**NEW SUMMARY OF SUBMISSIONS**  
**Local Structure Plan – 154 (L9001) Utley Road / 103 (L9002) Wattle Road, Serpentine**  
**PA20/786 – Close: 28/01/2021**

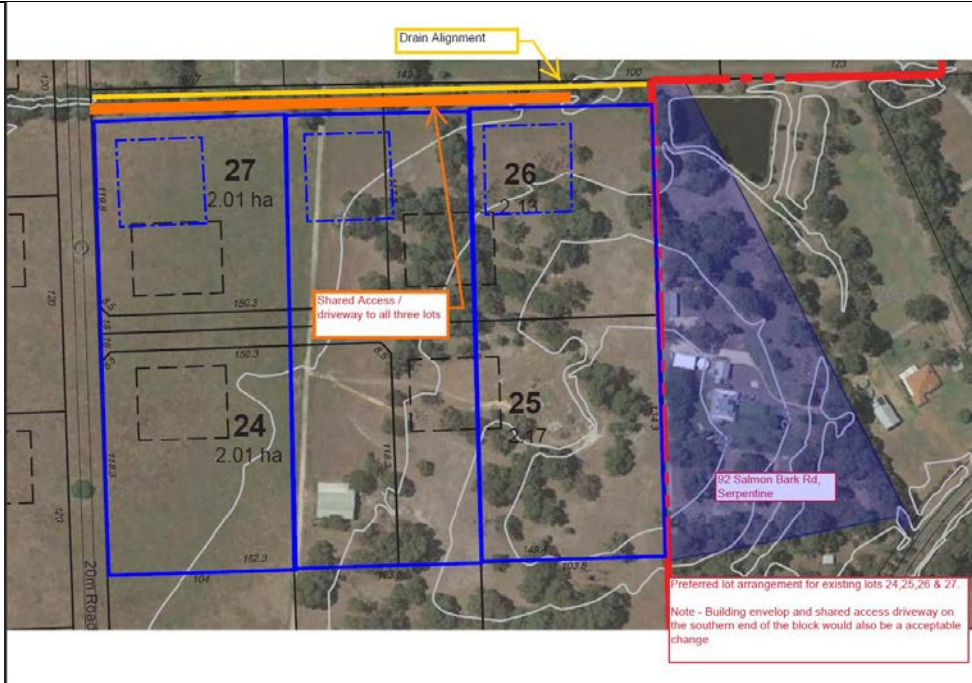
Submitter	No	Submitter Comments	Applicant Comment	Officer Comment and Recommendation
		<p>on lot 154 is being considered for development.</p> <p>We request the shire considers demarcating said area as a nature reserve or parkland area.</p> <p>In addition to the environmental concern noted above, the current proposal leads to car headlight spill from the driveways of lots 25 &amp; 26 onto our house and horse paddocks.</p> <p>Our home is located approximately 25 meters from the West boundary fence. The master bedroom of our house is located on the western side of our home and on the 2nd floor with a large window which could mean we would be subject to light spill directly into our home and bedroom. Also, excessive lights onto the paddocks could lead to fright issues with the horses causing injury and or damage. See figure 1 below for detail.</p>	<p>N/A</p> <p>Substantial setbacks between houses will result, with the building envelopes being located on the western side of the lots.</p> <p>Nothing currently prohibiting dwelling construction in these locations. Comment not applicable (N/A)</p>	<p>reduction, windbreak and biodiversity support is required at subdivision stage.'</p> <p>It is recommended that the wording of Section 4.1, Part 1 be amended to include that all indicative subdivision layouts shown in this Local Structure Plan and associated appendices are subject to further investigation and detailed design at subdivision stage.</p>
